Access Compliance Report

Public Rights-of-Way

(Curb Ramps)

| Intersection ID: 10036062 | Main Street: RIVERGATE_PY | Cross Street: N/A | Location: NW |

| ADA ID: 7FA6E0F8D11B | Ramp Type: Perp | Initial Pass/Fail: Fail | Overall Compliance: No |

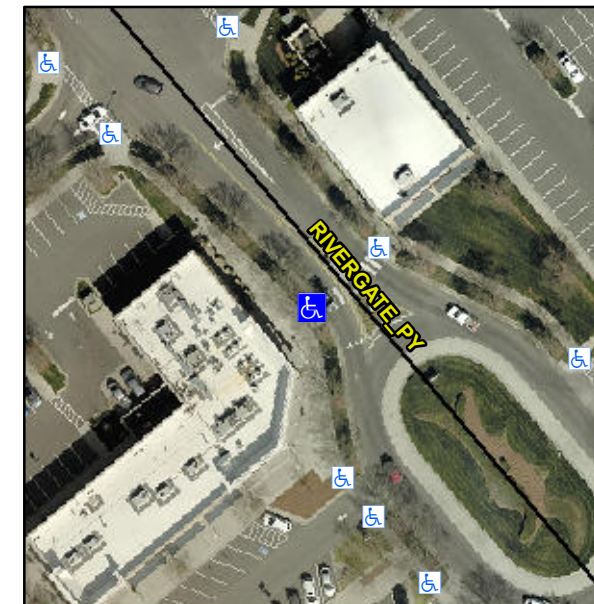
R304.5.1, R304.5.3

| Compliance | Description | Data | Compliance | Description | Data |
|------------|-----------------------|-------|------------|-----------------------------|------|
| No | Ramp Width (in) | 44.0 | No | Ramp XSlope (%) | 2.6 |

Remove & Replace Entire Ramp.
